Docket No. 50-336  
B18294

**Millstone Nuclear Power Station, Unit No. 2**  
**Response to a Request For Additional Information Regarding Proposed Revision to**  
**Final Safety Analysis Report**  
**Fuel Centerline Melt Linear Heat Rate Limit (PLAR 2-00-2)**

**Response to a Request For Additional Information Regarding Proposed Revision  
to Final Safety Analysis Report  
Fuel Centerline Melt Linear Heat Rate Limit (PLAR 2-00-2)**

<sup>H2P</sup> FIGURE 14.1.5.2-13  
PRESSURIZER PRESSURE (HFP POST-SCRAM STEAM LINE OUTSIDE CONTAINMENT BREAK  
WITH LOSS OF OFFSITE POWER)

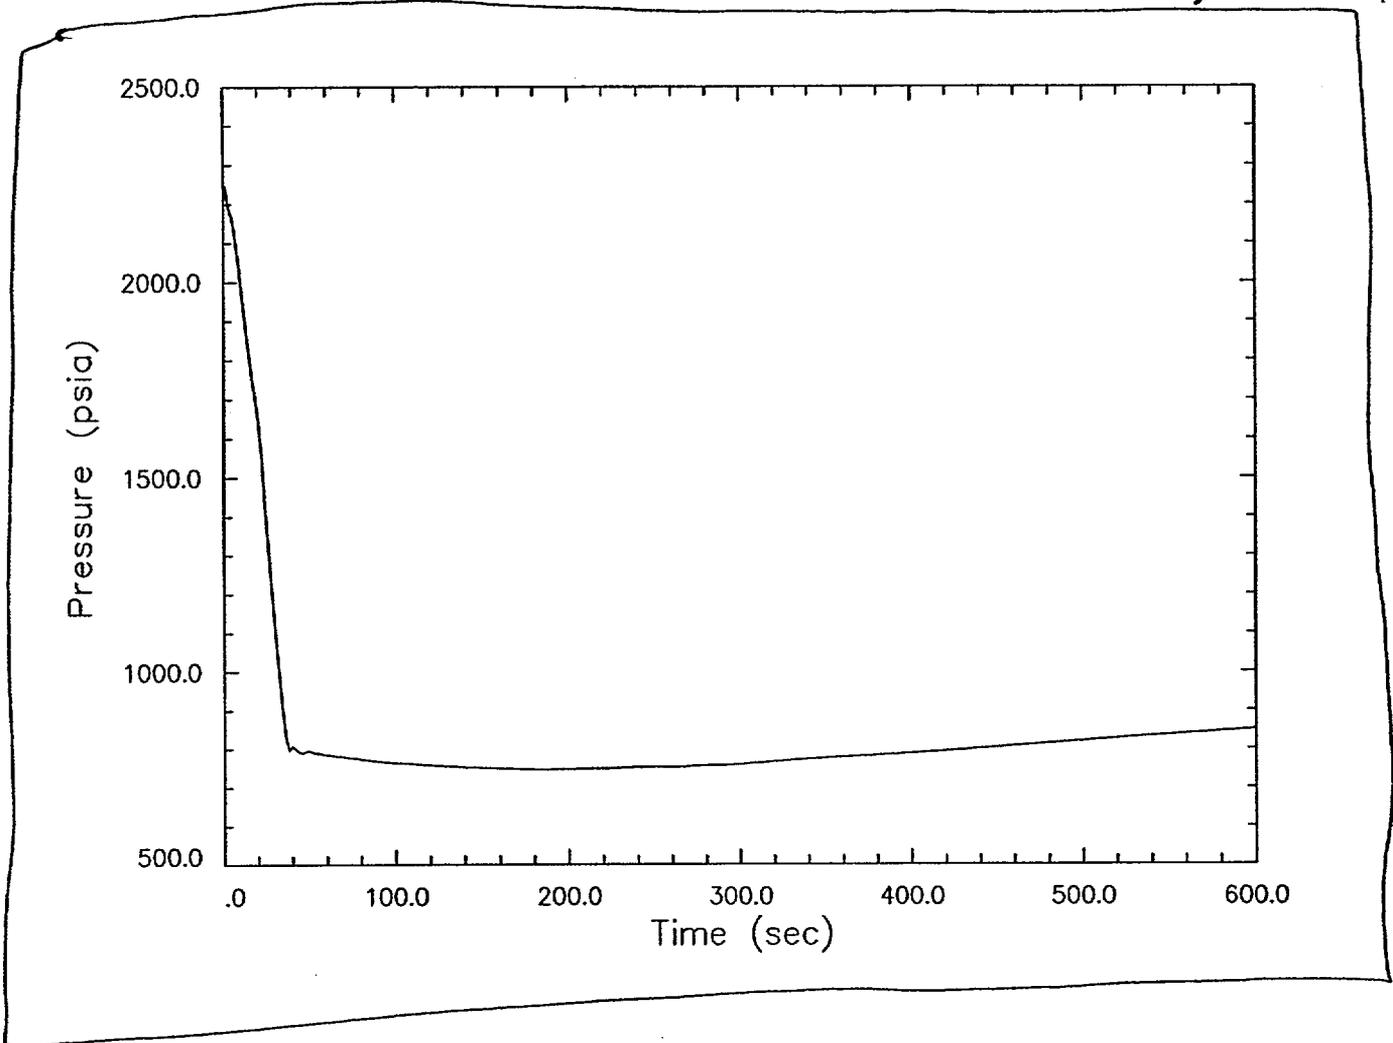
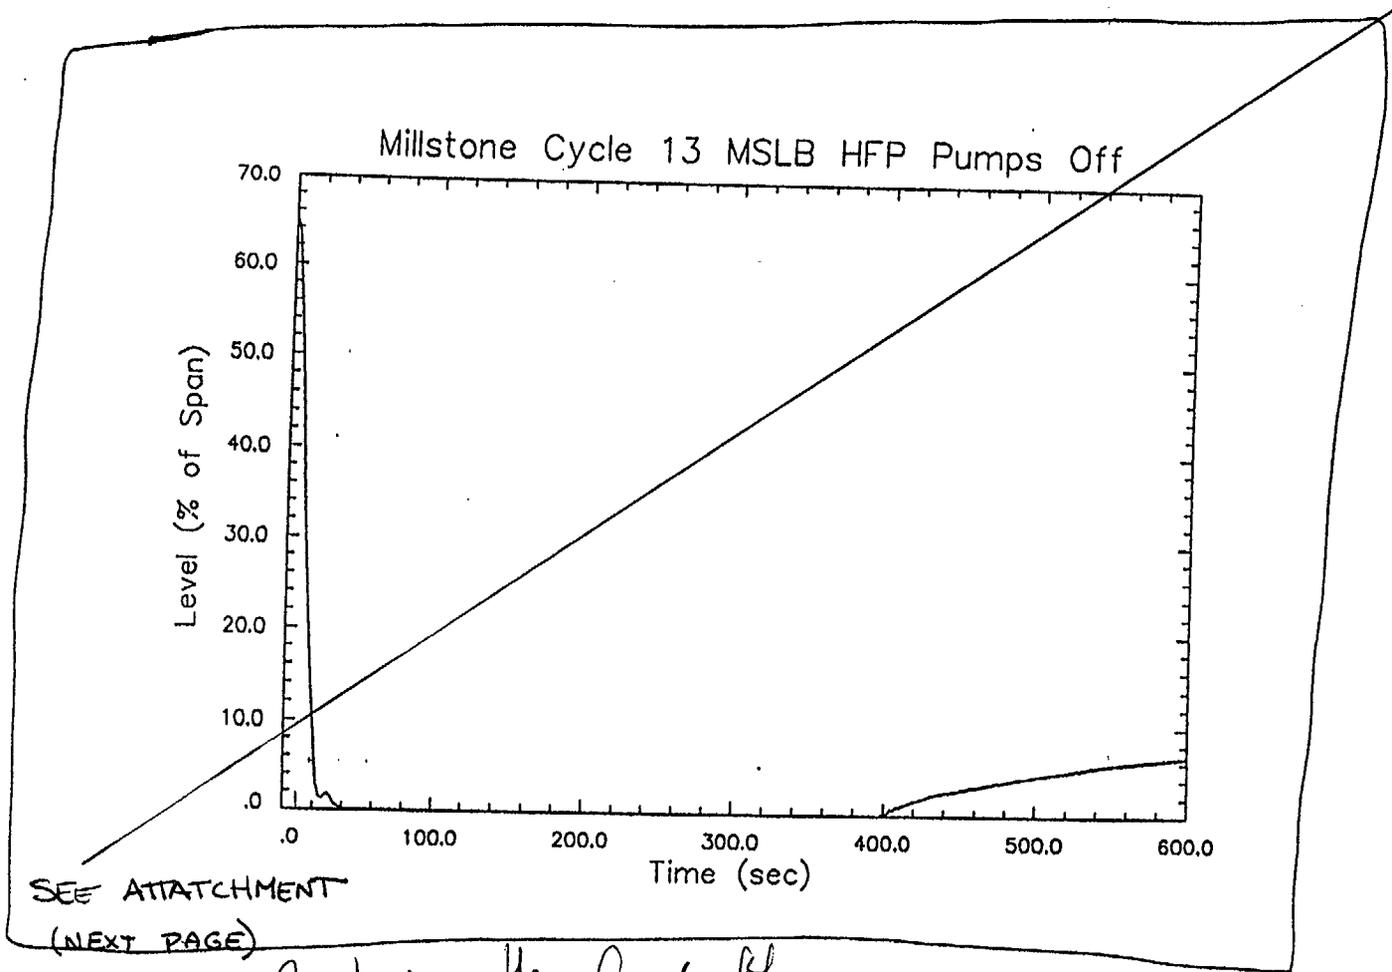
**Section 14.1.5.2.6.2 refers to Figs. 14.1.5.2-10 through 14.1.5.2-16 and Table 14.1.5.2-8 as representative of the HZP SLB event outside containment. However, these figures and table previously referred to the HFP event. Should they be revised accordingly?**

~~Figure 14.1.5.2-13 HZP Loss of Offsite Power  
(Pressurizer Pressure)~~

The cited figures and table have been updated by an earlier FSAR change associated with the Cycle 14 reload design change. To provide more clarification, Attachment 2 includes a markup of the FSAR Section 14.1.5, including the associated tables and figures. This attachment includes the changes to FSAR Section 14.1.5 associated with the Cycle 14 SLB reanalyses, and the proposed changes associated with the change to a cycle specific linear heat rate limit. The changes associated with the Cycle 14 SLB reanalyses are identified by FSAR Change Numbers 00-MP2-23 and 00-MP2-39 in the attachment. The proposed changes associated with the cycle specific linear heat rate limit are identified by FSAR Change Number 00-MP2-38 in the attachment.

*Replace with figure 14*

H2P **FIGURE 14.1.5.2-14**  
**PRESSURIZER LEVEL (HFP POST-SCRAM STEAM LINE OUTSIDE CONTAINMENT BREAK  
WITH LOSS OF OFFSITE POWER)**

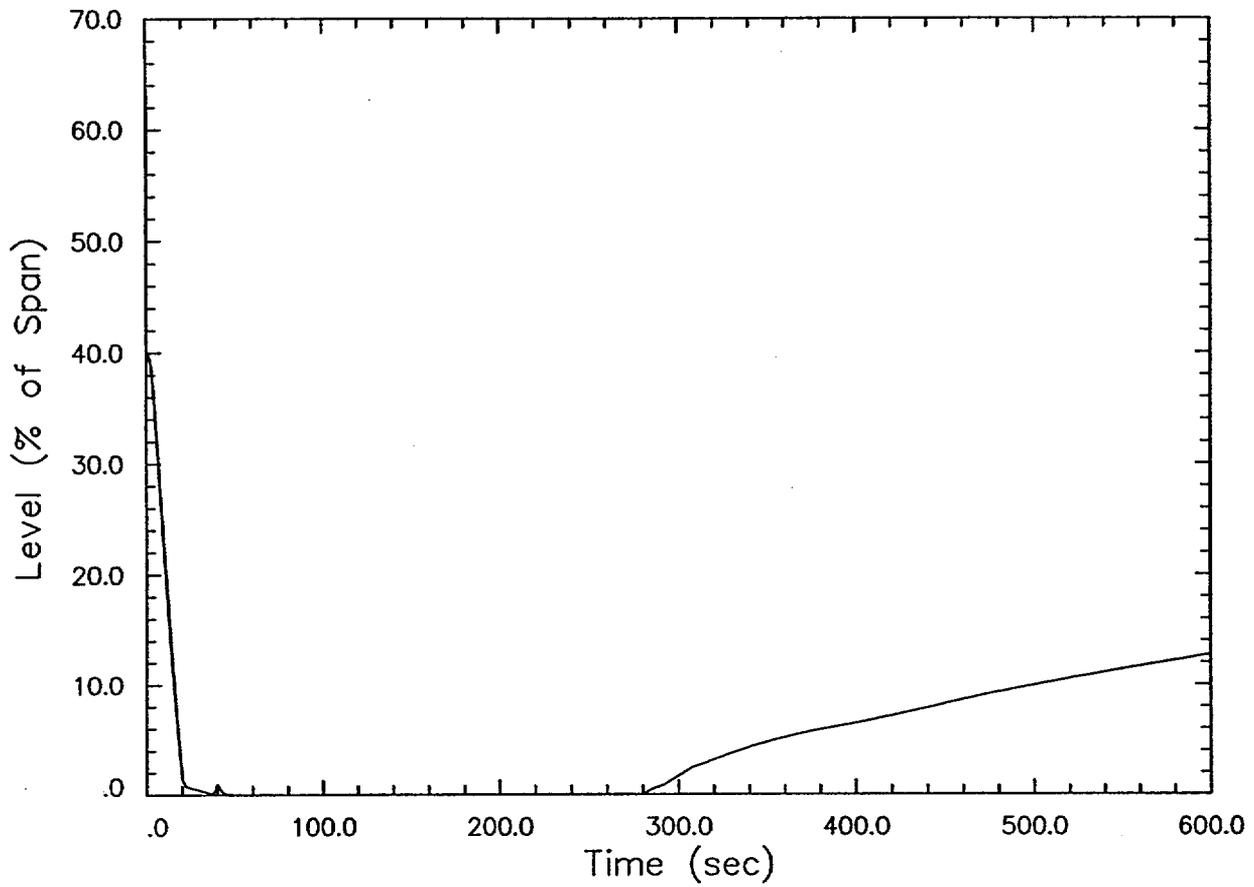
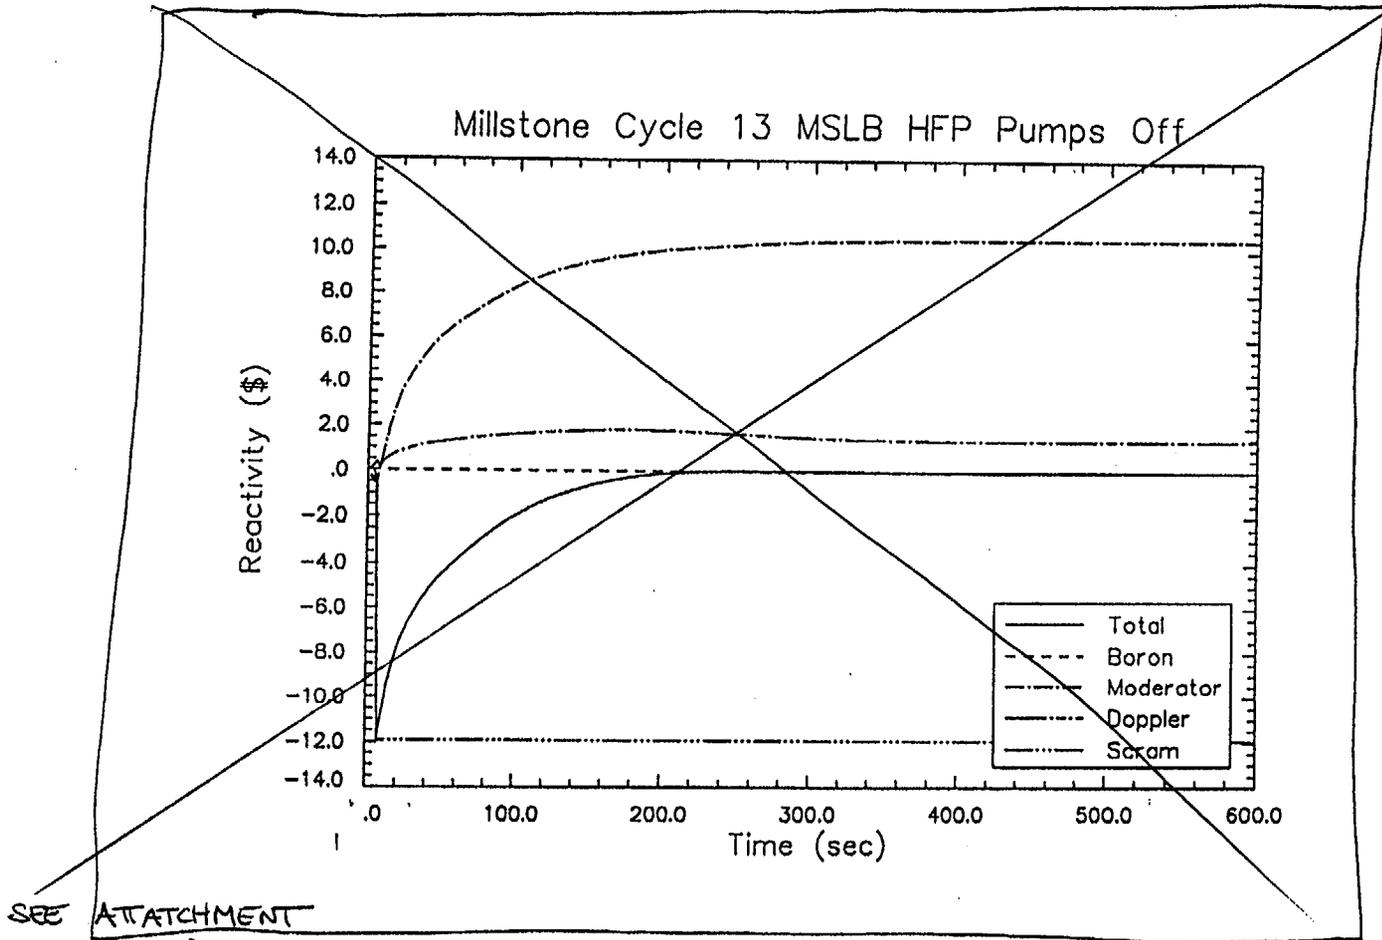
~~Figure 14.1.5.2-14 HZP Loss of Offsite Power  
(Pressurizer Level).~~

SEE ATTACHMENT  
(NEXT PAGE)

*Replace with figure 15*

H2P **FIGURE 14.1.5.2-15**  
**REACTIVITY COMPONENTS (HFP POST-SCRAM STEAM LINE OUTSIDE CONTAINMENT BREAK WITH LOSS OF OFFSITE POWER)**

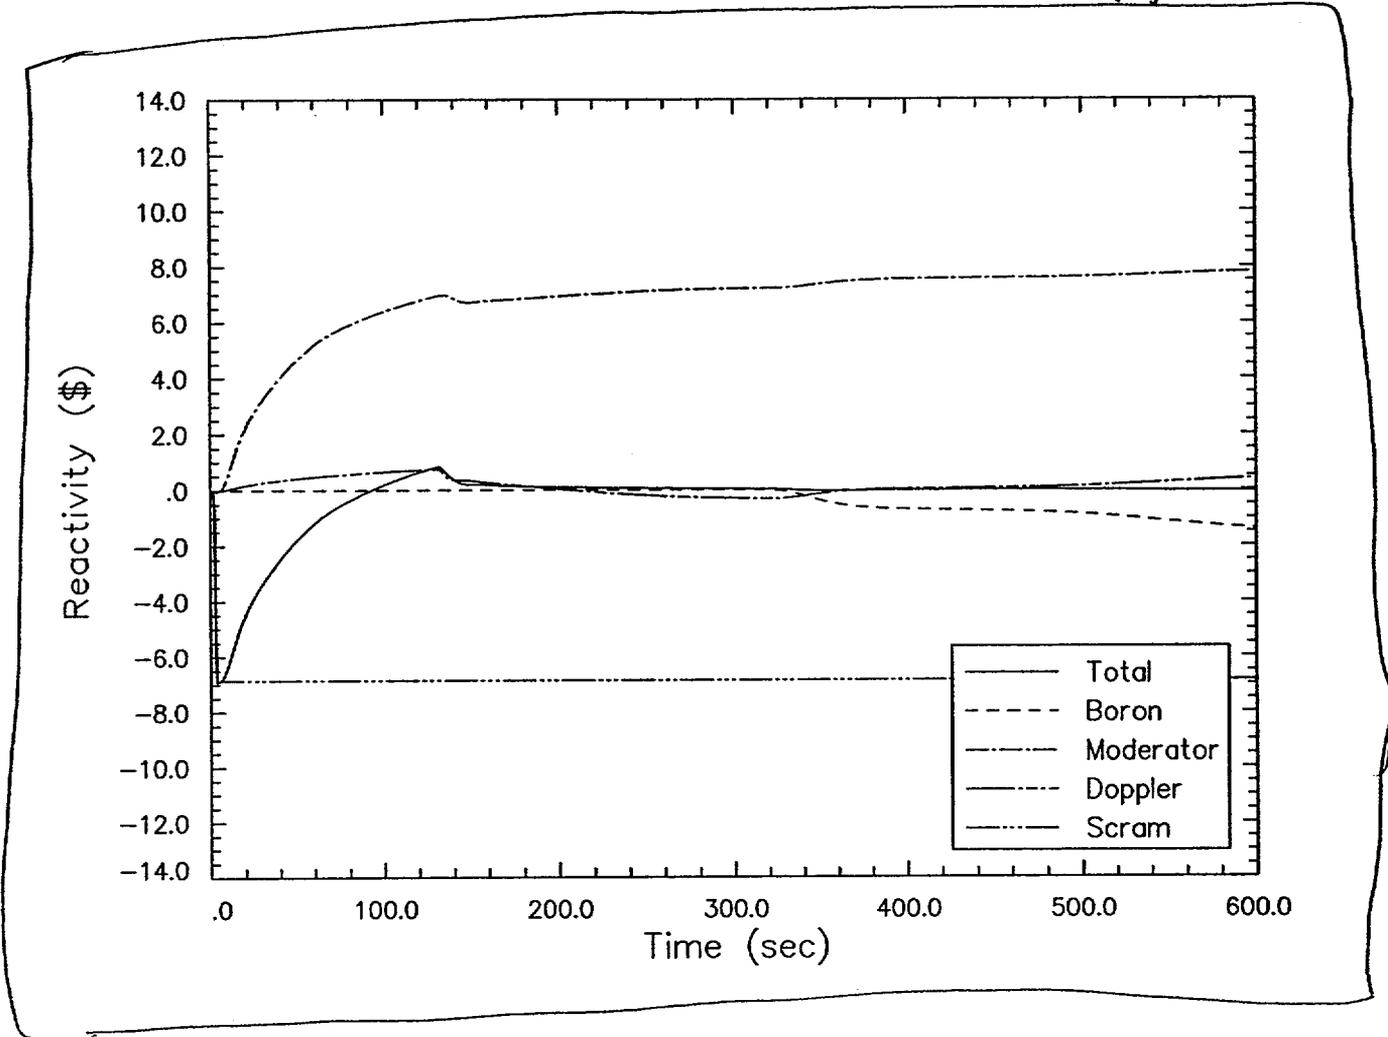
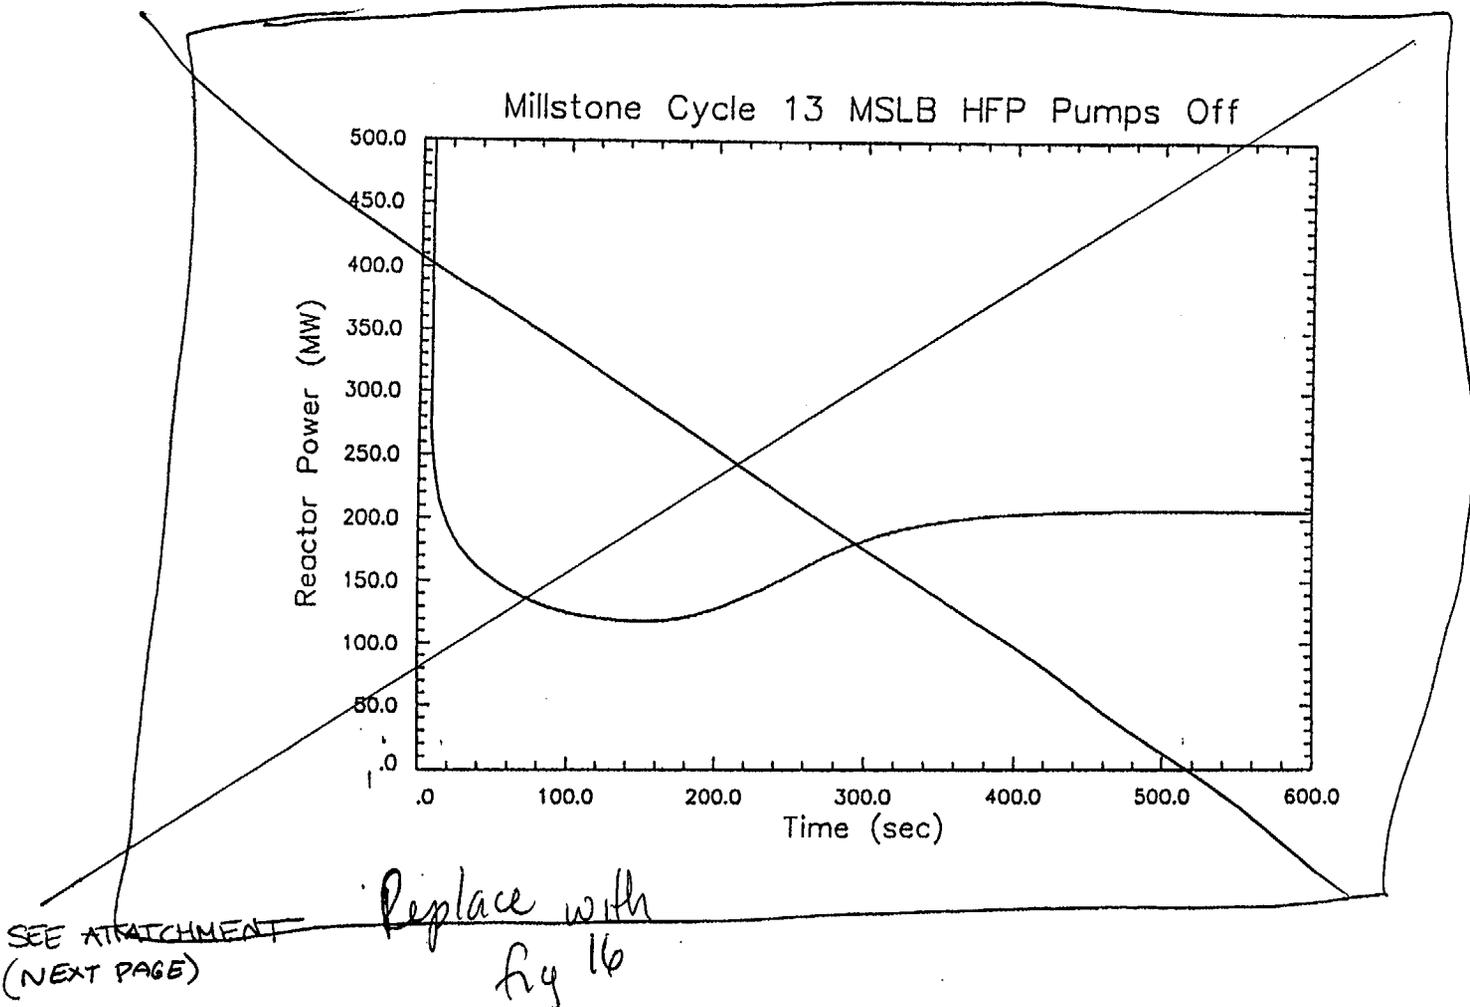
~~Figure 14.1.5.2-15 HZP Loss of Offsite Power (Reactivity Components)~~

H2P  
FIGURE 14.1.5.2-16  
REACTOR POWER (HFP POST-SCRAM STEAM LINE OUTSIDE CONTAINMENT BREAK WITH LOSS OF OFFSITE POWER)

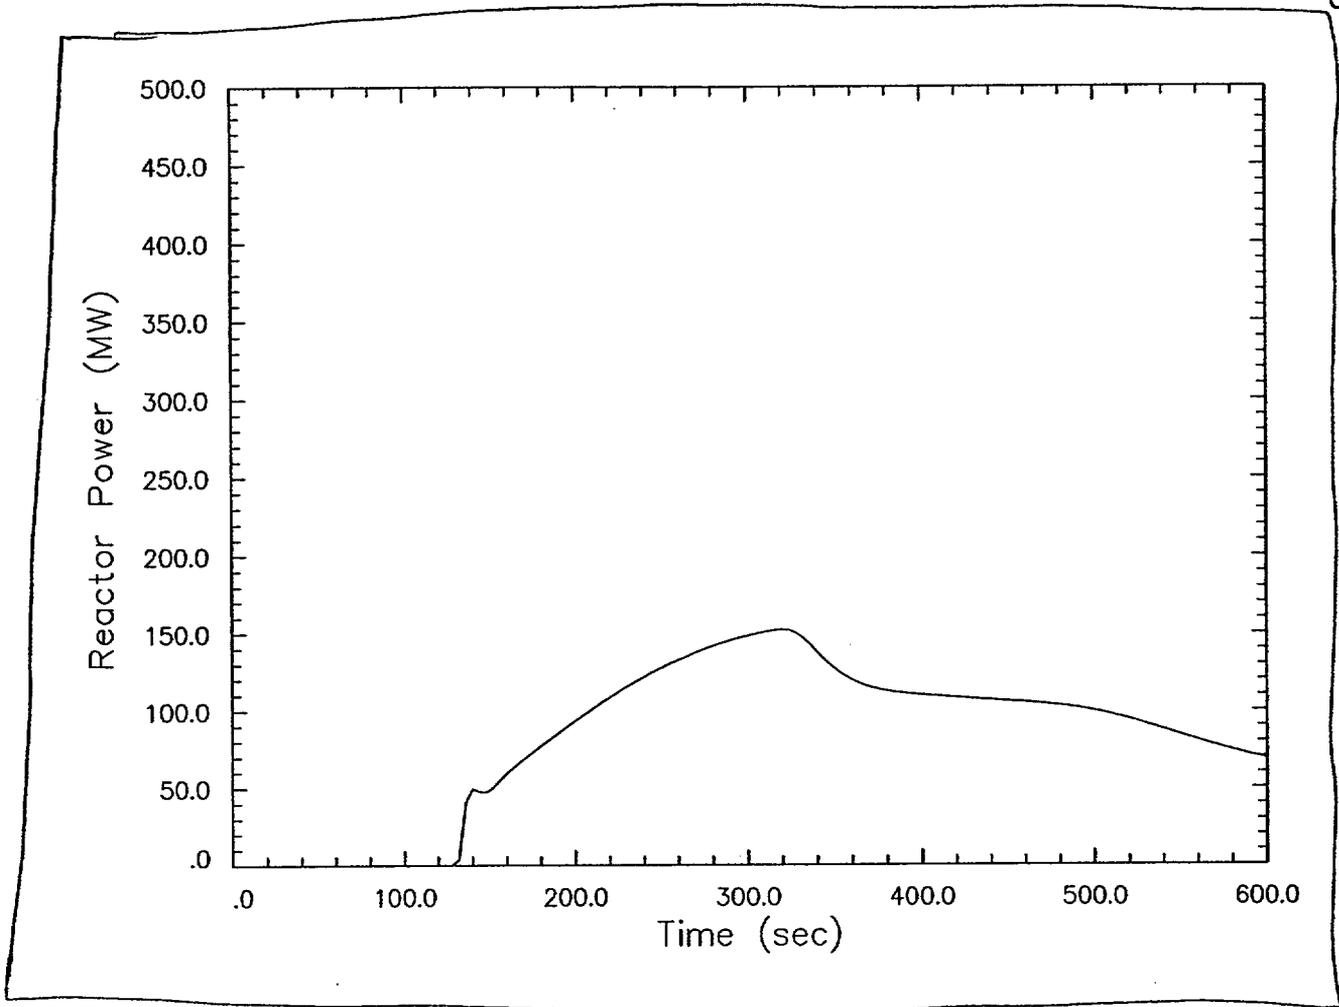
~~Figure 14.1.5.2-16 HZP Loss of Offsite Power  
(Reactor Power)~~
